# Hudson River Drinking Water Intermunicipal Council

December 1, 2020

Re: Champlain Hudson Power Express - Case 10-T-0139

# Exhibit A

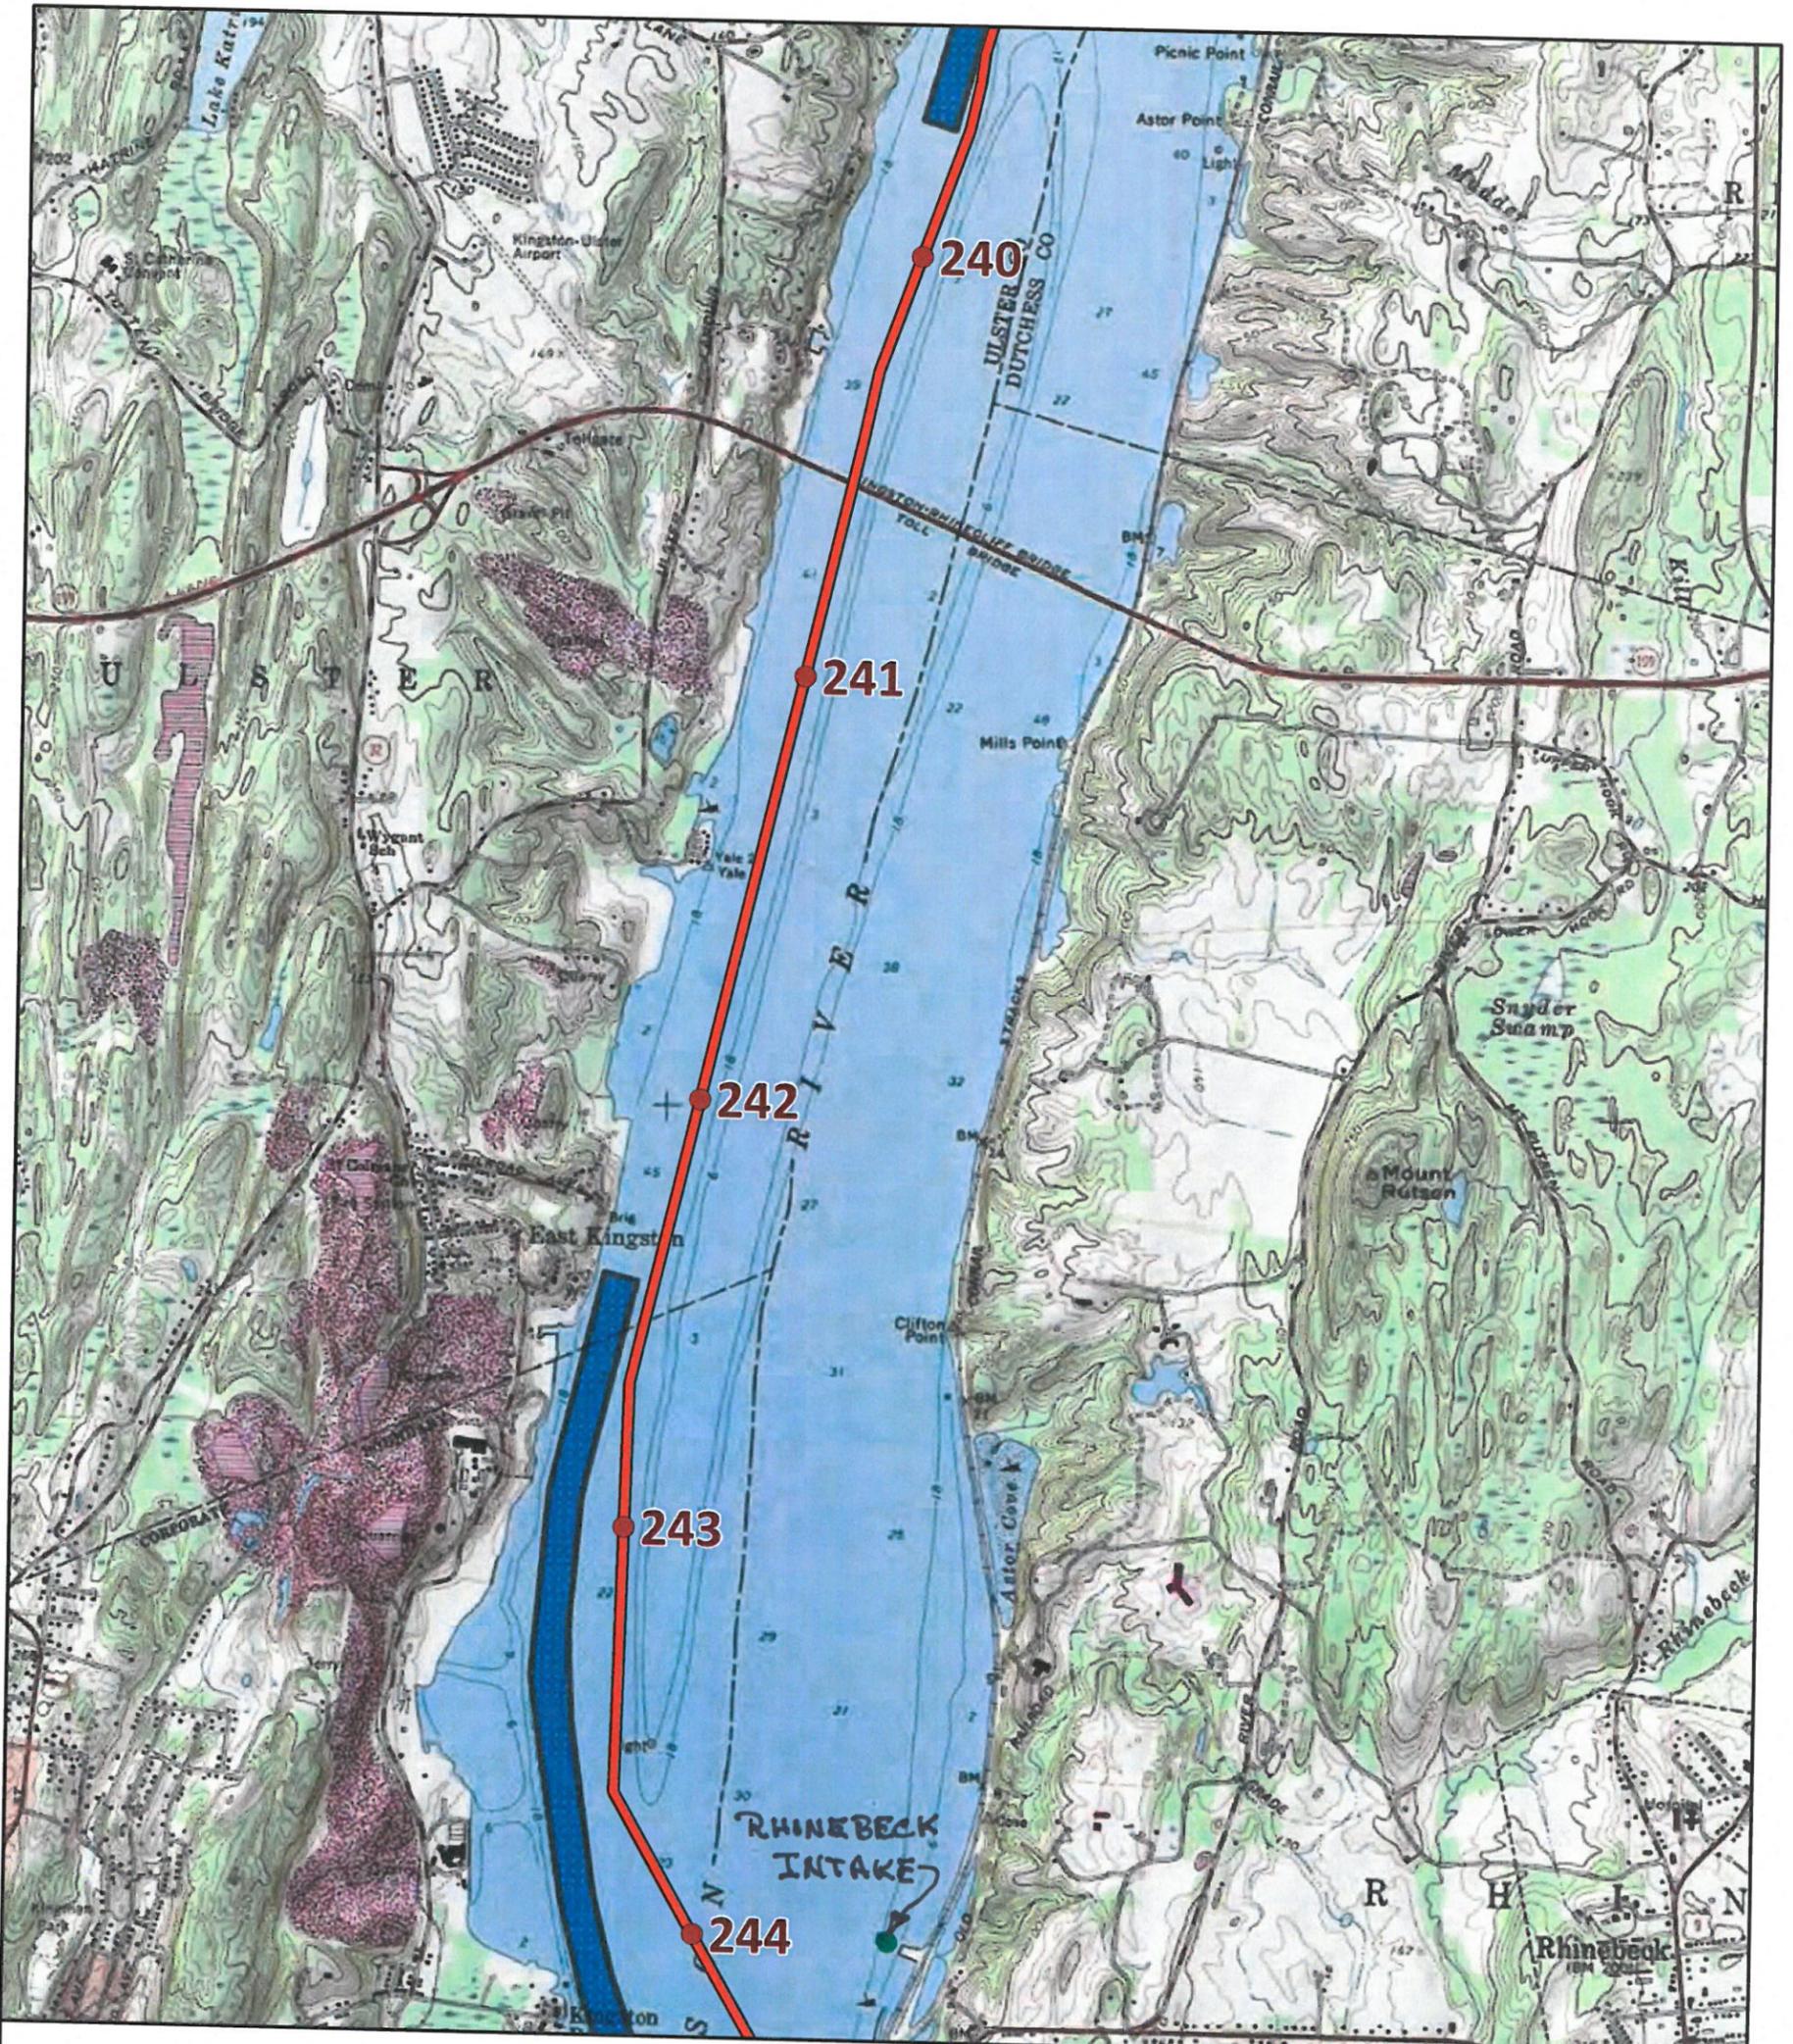
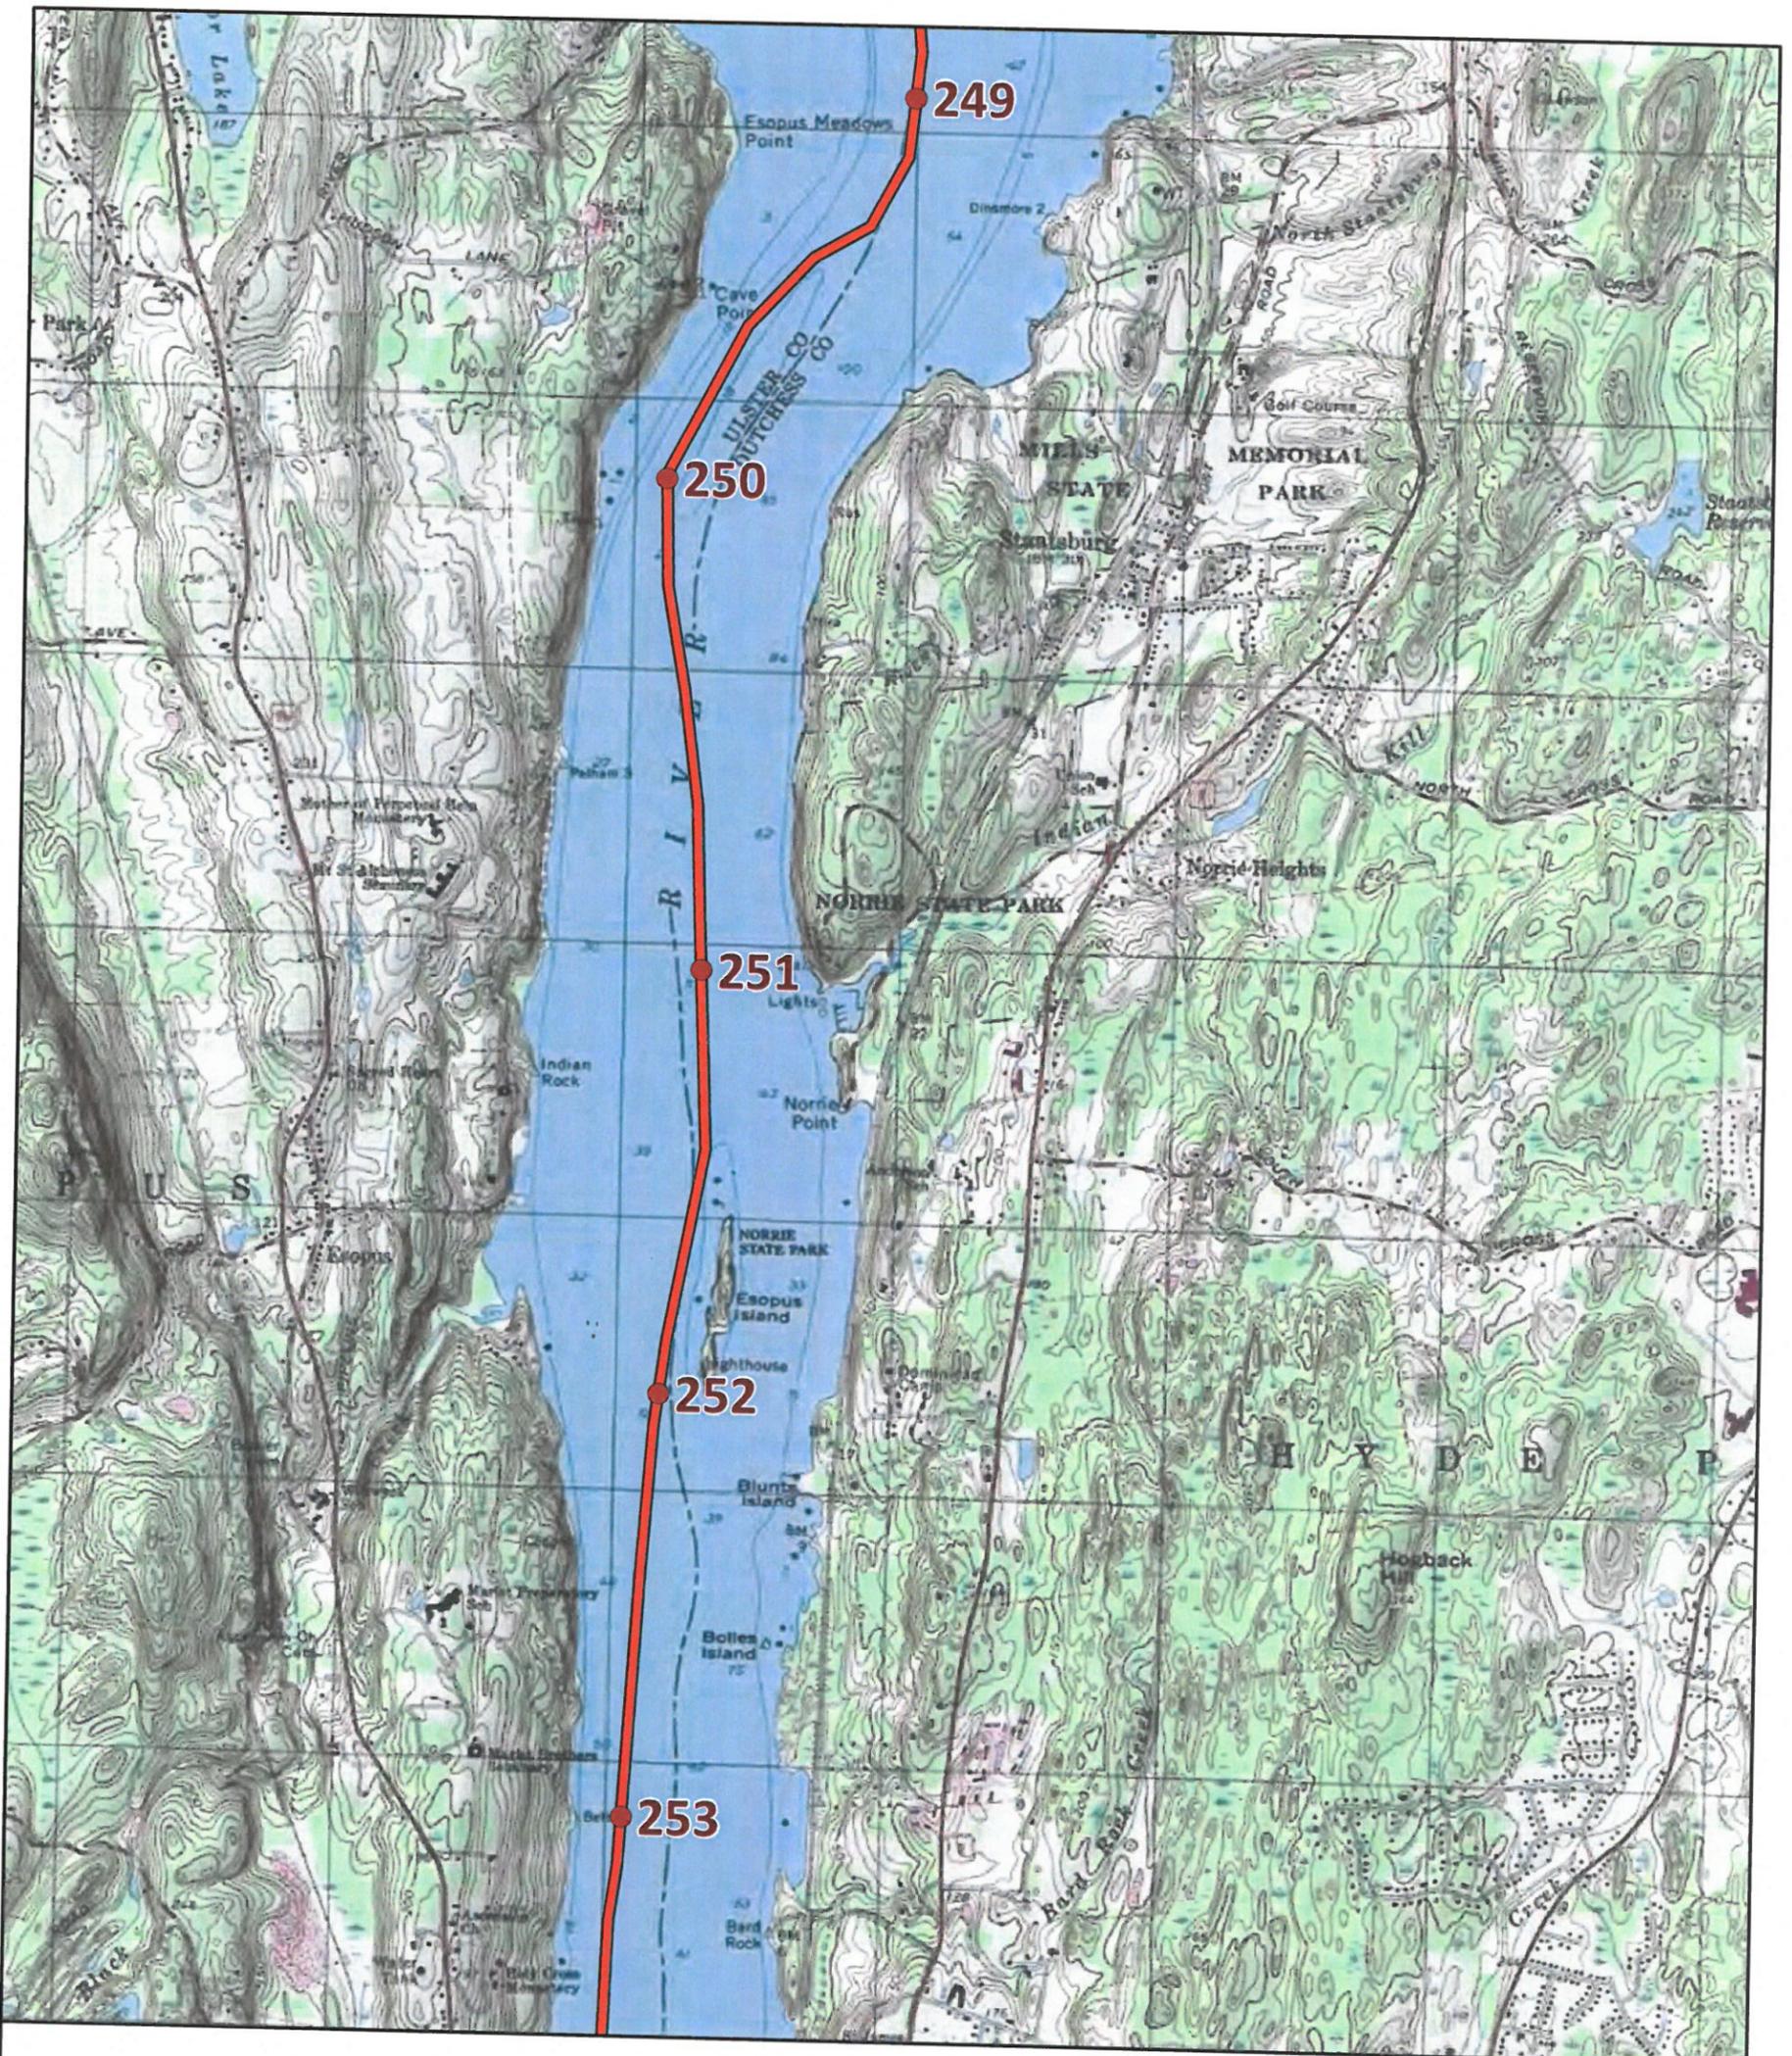
The proposed path of the Project passes within one-half mile of all five of our PWS intakes, as shown on the maps attached as Exhibit A. The cable excavation would be within 500 feet of Esopus's intake and would pass between Poughkeepsie's two intakes. Project documents make no mention of Lloyd's intake. Excavation of the river bottom threatens to suspend contaminated sediments that will be drawn directly into the PWS intakes.

In light of these risks, the most prudent course of action would be to modify the Project to a terrestrial route for the section of the Hudson River affecting drinking water intakes, from at least Kingston to Poughkeepsie. For example, the CSX corridor along the west side of the river could offer an alternative route that would avoid our water intakes completely.
